ATTACHMENT 2—CURRENT DRAFT OF BHOA LETTER

RE: Public Comment

Hollywood Center Project Environmental Case: ENV-2018-2116-EIR State Clearinghouse No.: 2018051002

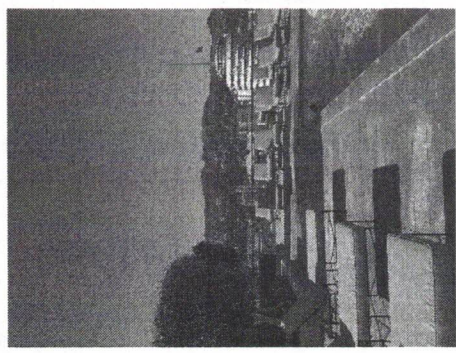
View looking south from the 101 freeway (a scenic highway) vine Exit 9A. The view of the Historic Building and Sign are iconic and a significant historic view is from the 101 freeway and at the exit elevation as one enters through the Hollywood gateway into the historic district and the iconic corner of Hollywood and Vine. The analysis shows existing/proposed views that are slightly east or west in the photos and do not capture the view of the Broadway Hollywood Building that exists. **This project will irreversibly reduce the importance of the Broadway Hollywood building and historic neon rooftop sign as an individual historic feature and as a contributor to the aesthetic character of the Hollywood Boulevard Commercial and Entertainment District. This meets potential aesthetics impact with a *Threshold (a) Would the Project substantially damage scenic resources, including but not limited to trees, rock outcroppings, and historic buildings within a City designated scenic highway?***

In addition to the building itself, the Broadway Hollywood Neon Rooftop sign is a historic sign that is a historic feature of the building and can be seen from the scenic highway. Blocking this vista requires specific compliance review under this EIR analysis and for impacts to the Broadway Hollywood Rooftop Neon Sign under the Hollywood Signage Supplemental Use District.

For context, and to capture the same line of sight from the opposite point of view from the top story of the Broadway Hollywood Building. **This project will directly impact and substantially block focal or panoramic views of and from this historic location.**

Figure 1: Bird's Eye view of only vehicle access point

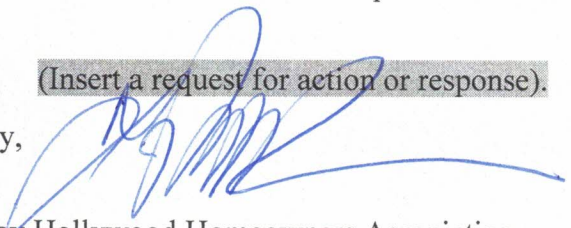
The N-2 LADOT Correspondence dated April 10, 2020, from the City Approving the Traffic study in the EIR, rates the intersection of Hollywood and Vine as an “F” during am/pm for 2027 projections. There is no Neighborhood Traffic Management Program analysis, nor project features, traffic signal analysis, or mitigation specifically address the significant impacts ~~to~~ unique to the Broadway Hollywood Building. The anticipated added traffic (vehicle and pedestrian) will create undue congestion and during operations and once the project is complete will significantly limit or restrict ingress and egress to the only vehicular entrance servicing the 96 live/work units. An updated impact analysis must be conducted to determine if the impacts of this project would pose life, safety, or a government taking of access (ingress/egress) to a private property of all individual (96) unit owners.

The only vehicle entrance for all building parking is located on vine through an alley between the building and the Hollywood Plaza building. Increased pedestrian or added traffic will block the only entrance to building parking. Taking access and/or increasing the burden of access to this building is a significant impact. There is no left turn into this alley, thus there is only one way access from Vine traveling south. Pedestrian flow impacts the ability for vehicles to enter or exit the alley onto the street.
